Preapplication Request Form

File #: 22-018PA

Site Address: 10271 SE 40th AVE Map & Tax Lot(s): 1S1E25DD05401 Zone: R-MD

6 unit cottage cluster

SITE PLAN

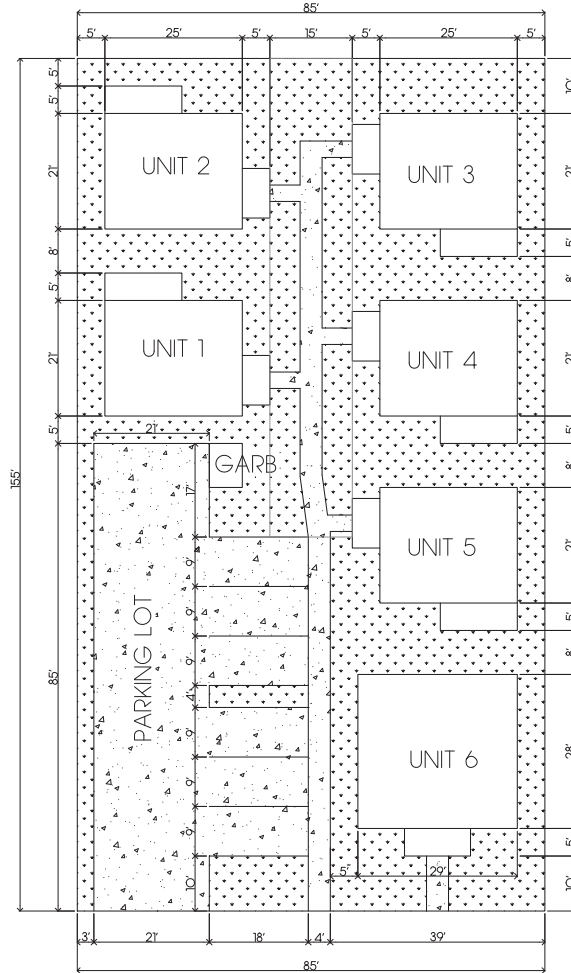
What sewer/water connections will be required for future individual lot configuration?

Would a sewer extension with separate laterals be required? If so, would the extension be allowed under the parking area? Can the existing lateral be used instead of a sewer extension?

Can a single water tap be made with a manifold type distribution located in the planting strip between the curb and sidewalk with a single meter in the manifold to service all 6 units and then be replaced with separate meters at a future date.

If there is no plan to divide the property in the future, what would be required for water and sewer connections?

Can drywell(s) be located under the parking area?

Can the parking area storm water drain to the city storm sewer located in 40? If not, can the water be treated in a swale and then go to the drywell system?

Can the existing driveway approach be used?

Is a handicap parking space required?

Will the plot plan as designed ie drive, parking, walkways and courtyard work as drawn?
